Service Bulletin

Service Bulletin No. / Date: TM TAE 125-0001, Revision 21 / May 2, 2018

Subject: Time Between Replacement (TBR) and Time Between Overhaul (TBO)

Type affected: Entire aircraft engine TAE 125-01, TAE 125-02-99, TAE 125-02-114

Fig. 1 Engine Version Identification

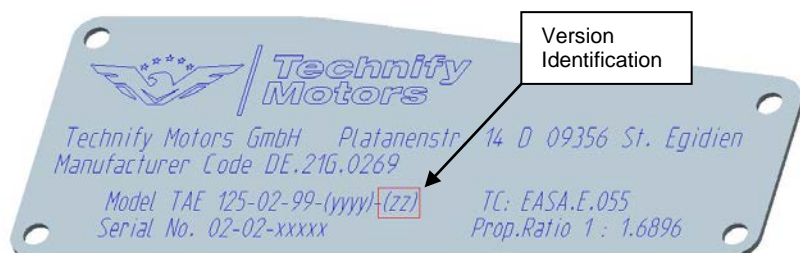
TAE 125-02-99 – Version 01 (see remarks for engine version identification):
1500 flight hours or 12 years after the date of initial operation, whichever occurs first. The date of the initial operation is the date the engine is operated for the first time or the 180th day after delivery of Technify Motors GmbH, whichever occurs first. Parts with a different life time are listed in the table under “Remarks”.

TAE 125-02-99 – Version 02, or later approved Versions (see remarks for engine version identification):
2100 flight hours or 12 years after the date of initial operation, whichever occurs first. The date of the initial operation is the date the engine is operated for the first time or the 180th day after delivery of Technify Motors GmbH, whichever occurs first. Parts with a different life time are listed in the table under “Remarks”.

Identification of Engine Version on Type Plate:
